Access Compliance Report

Public Rights-of-Way

(Curb Ramps)

Intersection ID: 28112	Main Street: PROVIDENCE_RD	Cross Street: BELICOURT_DR	Location: SW
ADA ID: 7D0A92E891C9	Ramp Type: Para	Initial Pass/Fail: Fail	Overall Compliance: No
Severity Score: 13.75			
Codes/Mitigation Info/Possible Solution		Field Measurements/Component Compliance

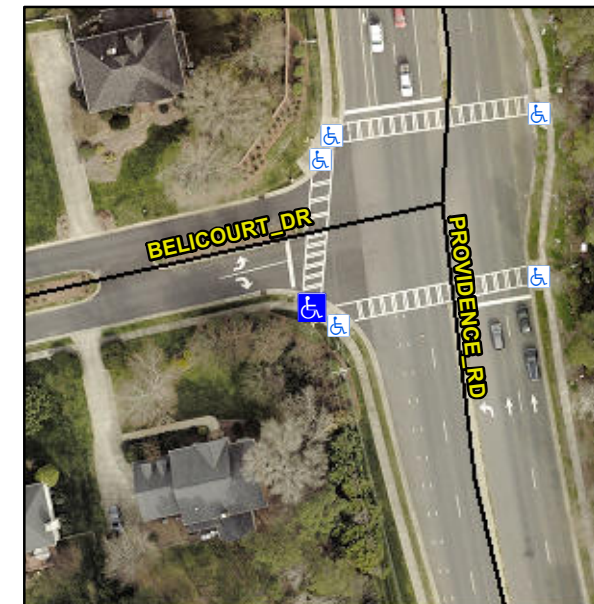
Surveyor Notes:

LT RP < 5%

PROW/ADA:

R304.5.3, R304.3.2

Possible Solutions:

Remove & Replace Entire Ramp.
